Re: Response to Request for Additional Information

This letter provides the information requested by your letter dated June 22, 2010, "Rensselaer Polytechnic Institute, Request for Additional Information Regarding the Renewal of Facility Operating License (TAC No. ME1591)."

A020
RPR

Response to Detailed Questions

Figure 1: RCF Management Organization

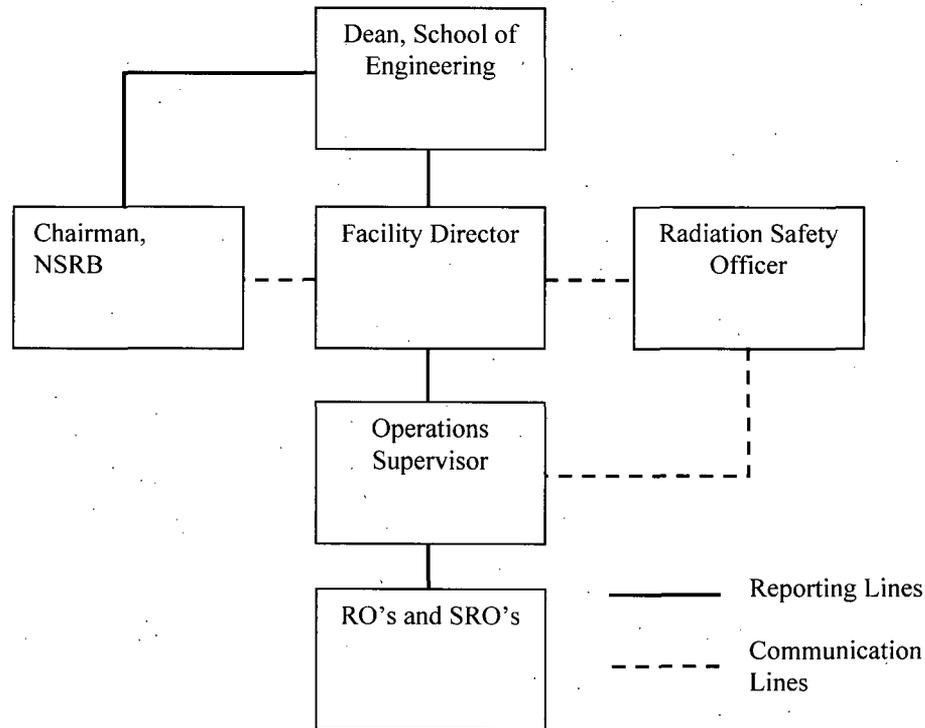
54. Figure 6.1 of proposed TS 6.1 does not indicate any communication lines as recommended in Figure 1 of ANSI/ANS-15.1. Proposed TS 6.1.2 and 6.2 describe communication lines between the Facility Director and the Nuclear Safety Review Board (NSRB) and the RPI Radiation Safety Officer. Revise Figure 6.1 to include communication lines, or justify not including such requirements.

55. Figure 6.1 of proposed TS 6.1 does not include Level 3 and Level 4 of the organizational structure. Revise Figure 6.1 to include Level 3 and Level 4 of the organizational structure, including appropriate reporting and communication lines, or justify not including such requirements.

Response: A new Figure 6.1 was drawn showing reporting and communication lines.

Response: A new Figure 6.1 was drawn showing reporting and communication lines.
